# Work Order ID 84527

Item ID: D212-664-101 Accept **\*N900040100\*** Setup Start **\*NS1\***  
 Revision ID: Stop **\*NS2\***  
 Item Name: Crosstube Fwd  
 Start Date: 15/05/2012 Start Qty: 1.00 **\*1\*** Cust Item ID:  
 Required Date: 05/06/2012 Req'd Qty: 1.00 **\*1\*** Customer:  
 Reference:

DRAWING NO. D212-664-141	TITLE XTUBE ASSY (205/212/412 HI FWD)	REV. D	DART AEROSPACE LTD ENGINEERING ORDER		D.E.O. NO. D212-664-141-D-1	SHEET NO. SHEET 1 OF 2	SCALE NTS
DRAWN	CHECKED	MFG. APPR.	APPROVED	DE APPR.			
DATE 11.04.07	DATE 11.04.11	DATE 11.04.12	DATE 11/04/12	DATE 11.04.12

DRAWING NO. D212-664-141	TITLE CROSSTUBE ASS'Y (205 HI FWD)	REV. D	DART AEROSPACE LTD ENGINEERING ORDER		D.E.O. NO. D212-664-141-D-2	SHEET NO. SHEET 1 OF 1	SCALE NTS
DRAWN <i>UP</i>	CHECKED <i>ASS</i>	MFG. APPR. <i>AB</i>	APPROVED <i>MD</i>		DE APPR. <i>TH</i>		
DATE 11.07.15	DATE 11.07.20	DATE 11.07.21	DATE 11/07/21		DATE 11.07.21

**D212-664-141/-141B  
ASSEMBLY DETAIL**

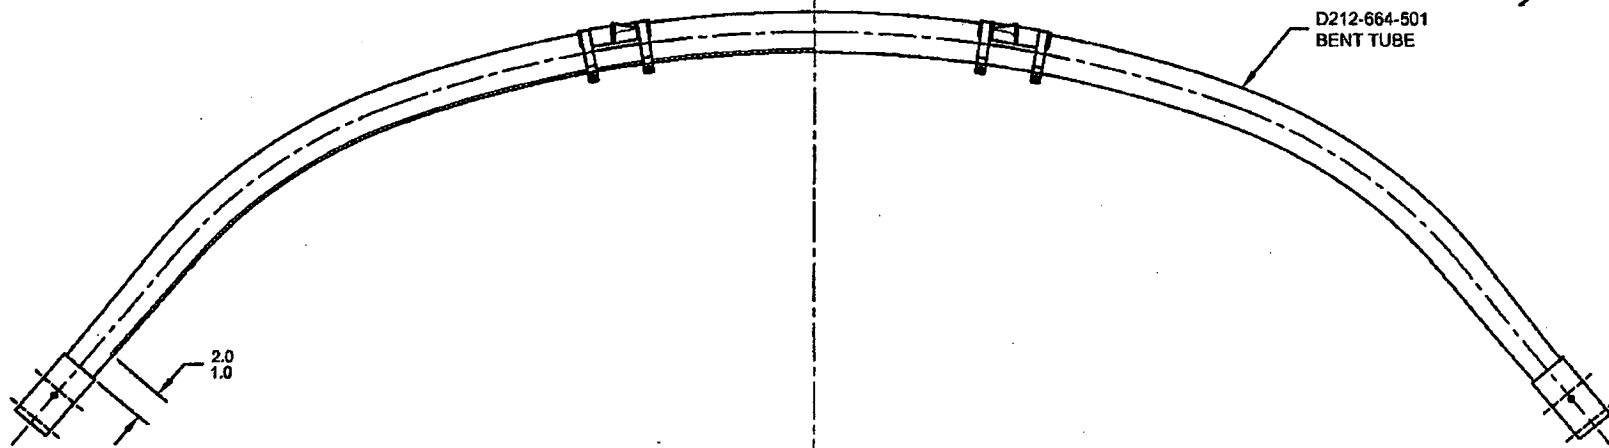
ADD AN INSPECTION WINDOW TO UNDERSIDE OF CROSSTUBE.

NOTES 2 OF SHEET 1 IS AMENDED AS FOLLOWS:

- 2) FINISH: CHEMICAL CONVERSION COAT PER DART QSI 005 4.1  
PRIME INSIDE AND OUTSIDE PER DART QSI 005 4.2  
MASK UNDERSIDE OF CROSSTUBE AS SHOWN (HATCHED AREA) AND  
PAINT OUTSIDE PER DART QSI 005 4.2  
REMOVE MASKING AND APPLY CLEAR COAT

- 2) FINISH: CHEMICAL CONVERSION COAT PER DART QSI 005 4.1  
PRIME INSIDE AND OUTSIDE PER DART QSI 005 4.2  
PAINT OUTSIDE PER DART QSI 005 4.2

MASK AREA PRIOR TO PAINTING,  
REMOVE MASKING AFTER PAINT  
AND APPLY CLEAR COAT
